# PDS-21 MOTOR UPDATE – 2021

March 23, 2021 – This is notice to inform distributors and consumers that the 2 Stage Vac Motor utilized in the VIKING PDS-21 (Pressurized Drying System) Wall Cavity Dryer has been updated.

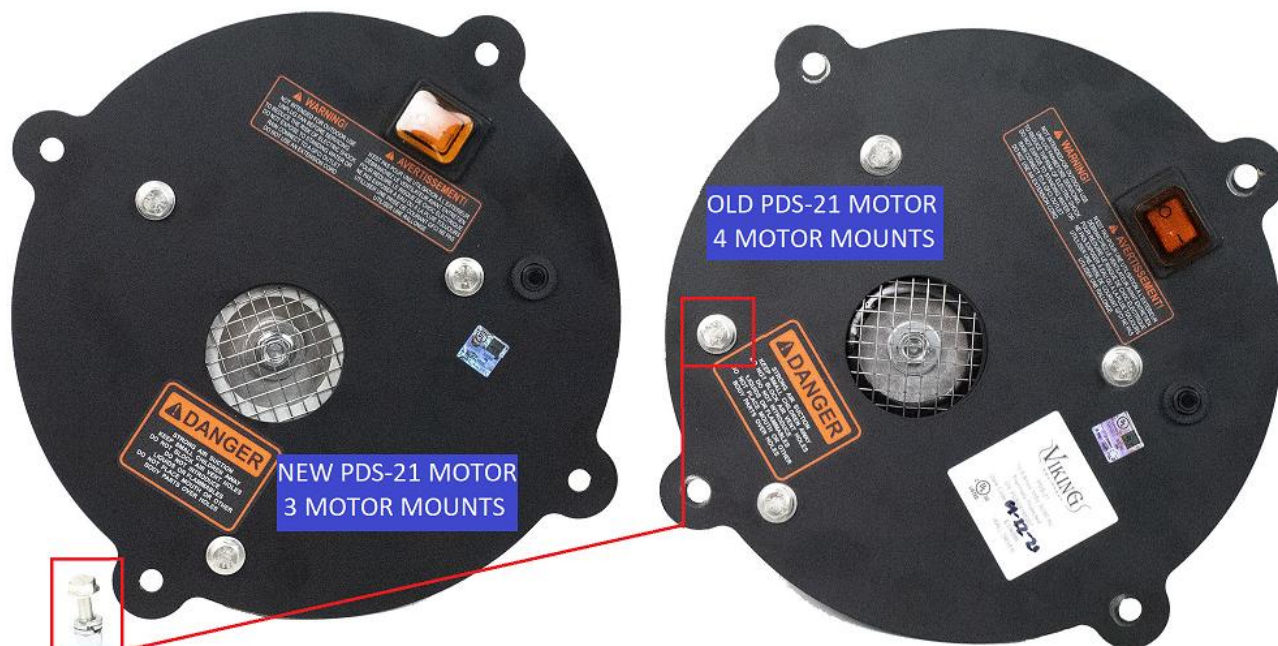
The above image displays the new motor (left) and previous motor (right) attached to the faceplate. Please note that the new motor on the left now has 3 motor mounts, reduced from 4 motor mounts seen on the right. New motors can be attached to existing faceplates with 4 mounting holes by utilizing 3 of 4 mounting points. The 4<sup>th</sup> motor mount on the old faceplate (red square on the right) can be blocked with nuts, bolts, & washers (red square on the left).

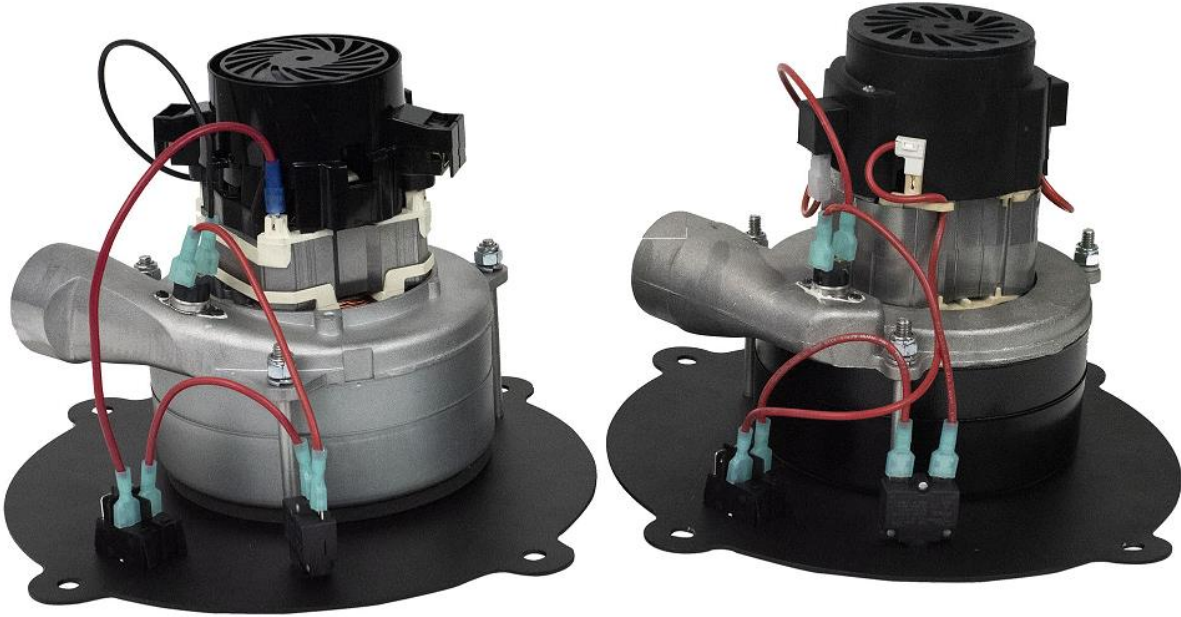
Please note that the fan covers on each motor are different. This will help in distinguishing which replacement brushes you will need to order. New motor (top left) previous motor (top right) correlate with the brushes seen below.
